Staff Report for Item 3

Application Number: H15-01-1665

Address: #702 Pearl Street

Partial demolition of side and rear additions with no build back.

DEMOLITION PLAN

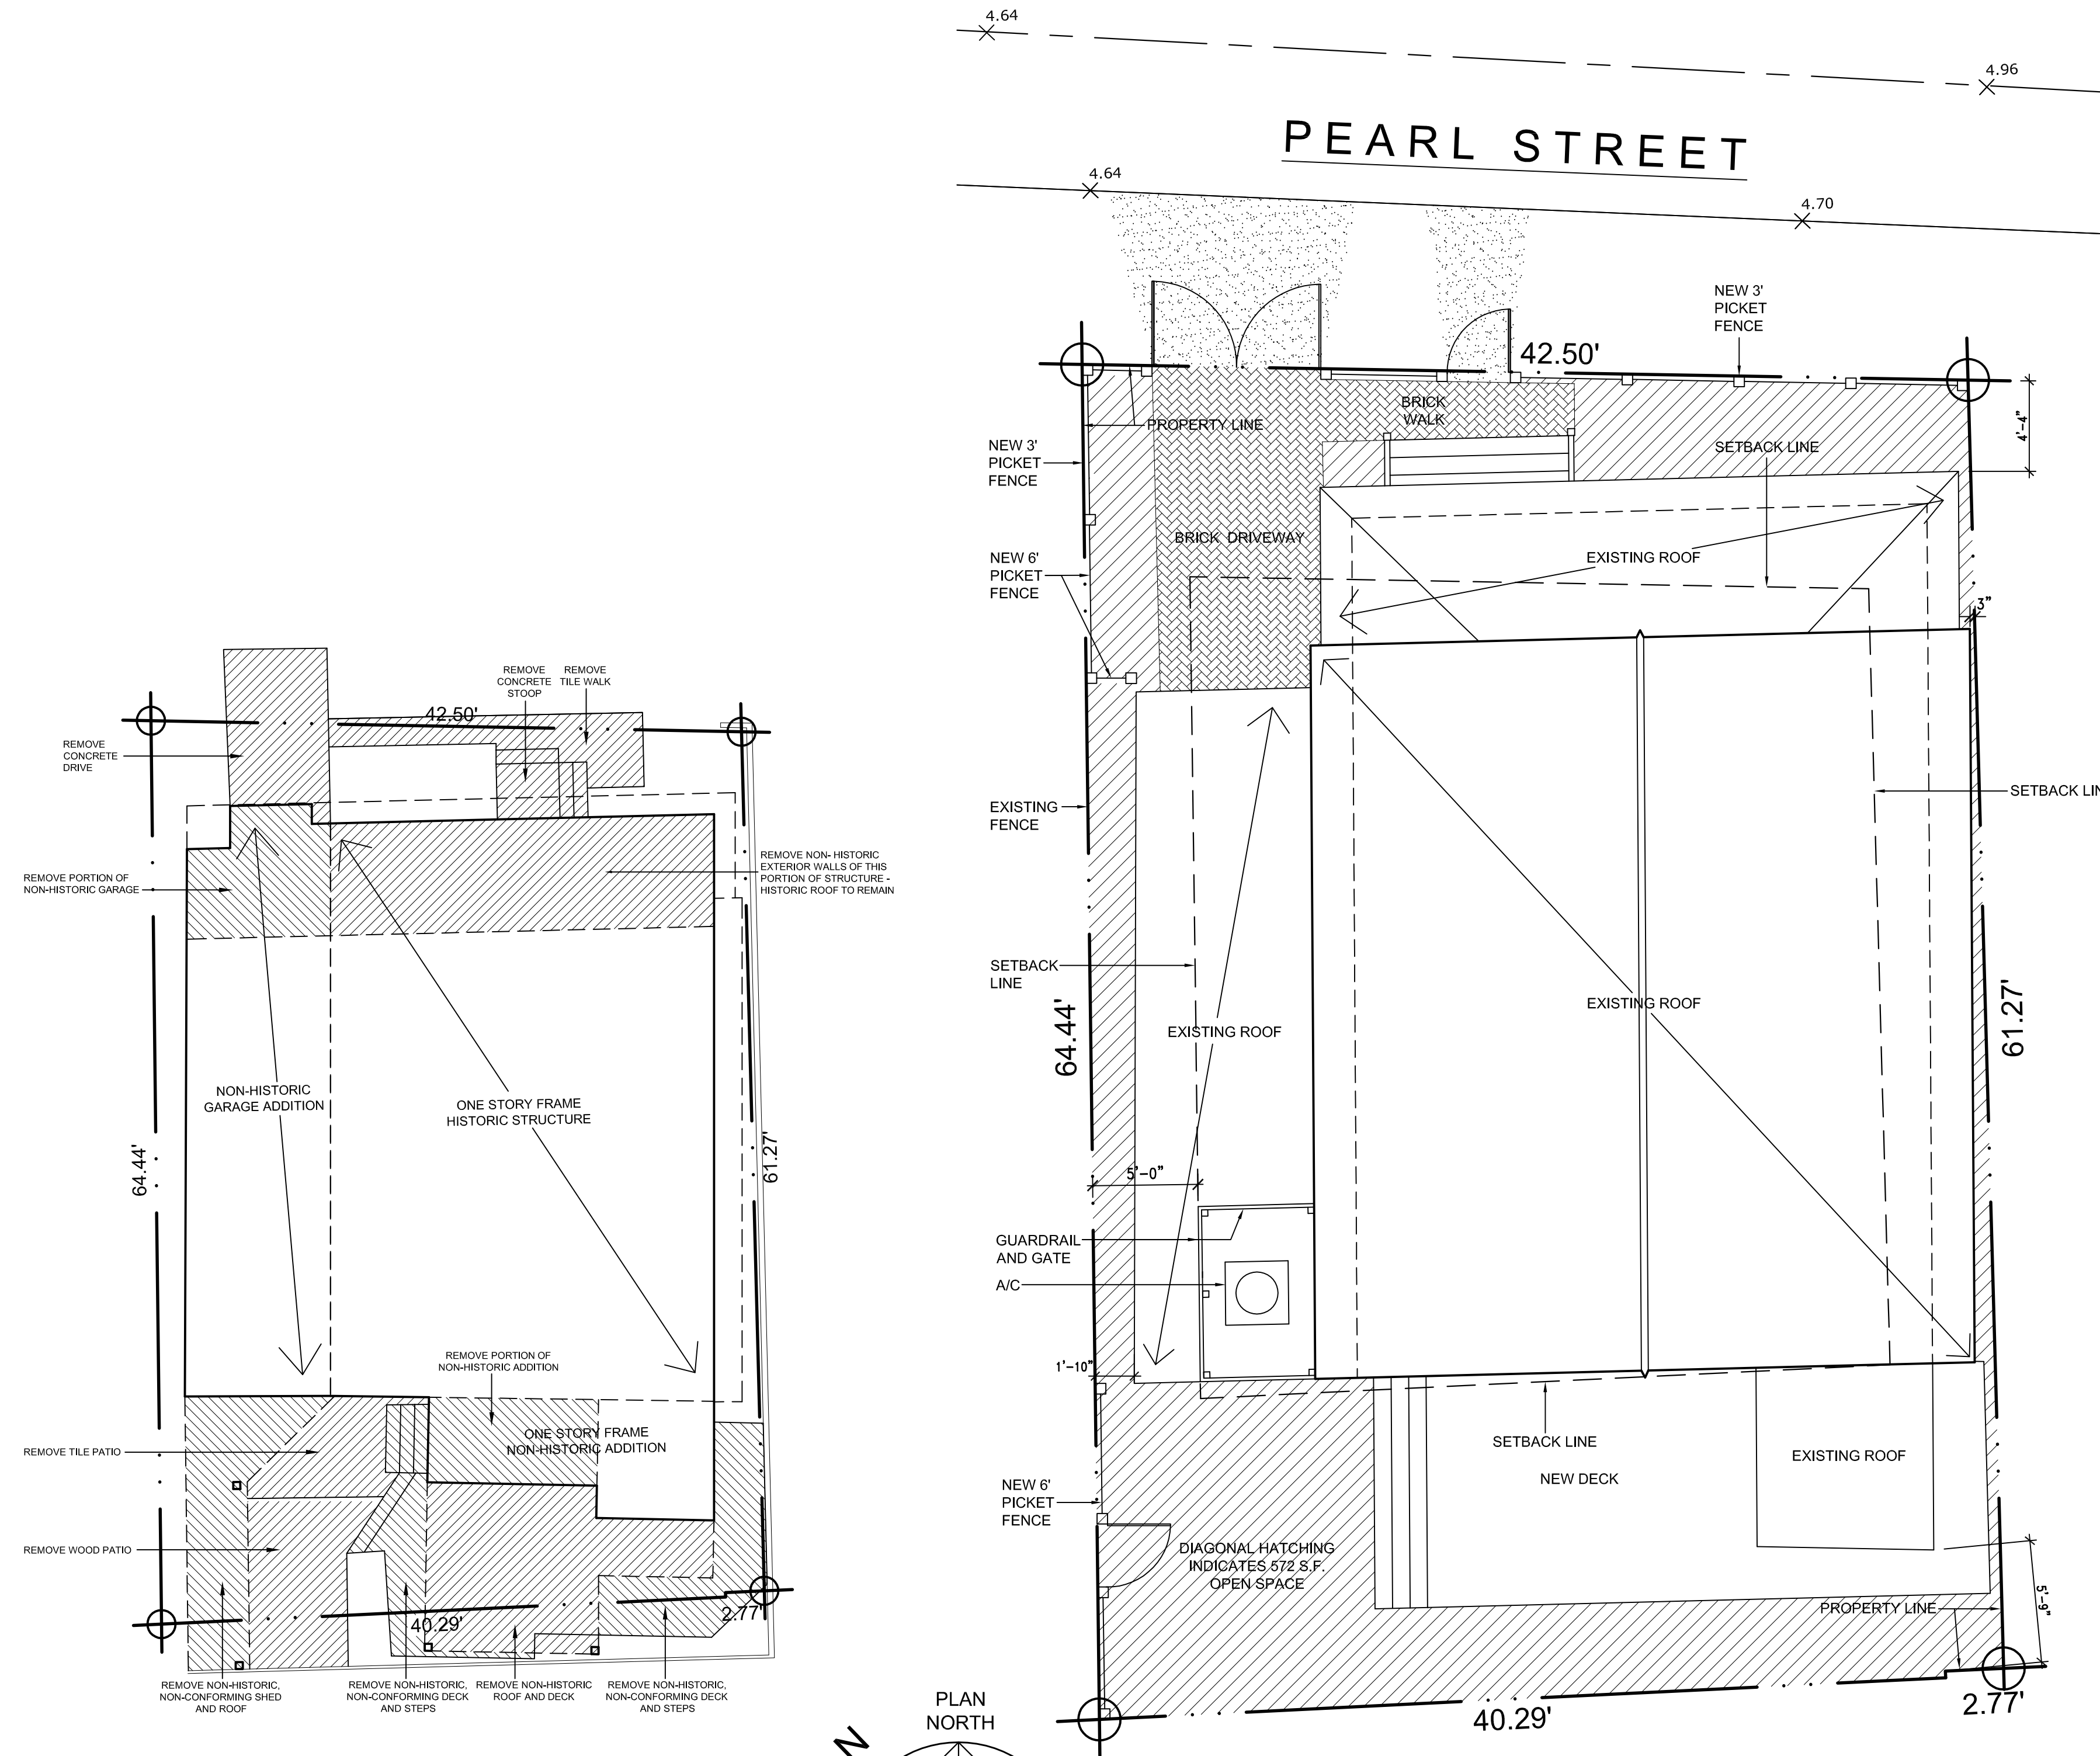
This Certificate of Appropriateness proposes the demolition of a non-historic rear addition and partial demolition of the side garage addition.

- (1) The demolition will not diminish the overall historic character of a district or
- (2) Nor will it destroy the historic relationship between buildings or structures and open.
- (3) This demolition will not affect the front building façade. Instead, the demolition will improve the front building façade.
- (4) Staff does not believe elements that are proposed to be demolished will qualify as contributing as set forth in Sec. 1021-62(3).

THE PORTIONS WHICH ARE REQUESTED TO BE REMOVED ARE RECENT ADDITIONS AND ARE NON-HISTORIC AND THEIR REMOVAL WOULD NOT DIMINISH THE HISTORIC CHARACTER OF THE DISTRICT OR NEIGHBORHOOD.
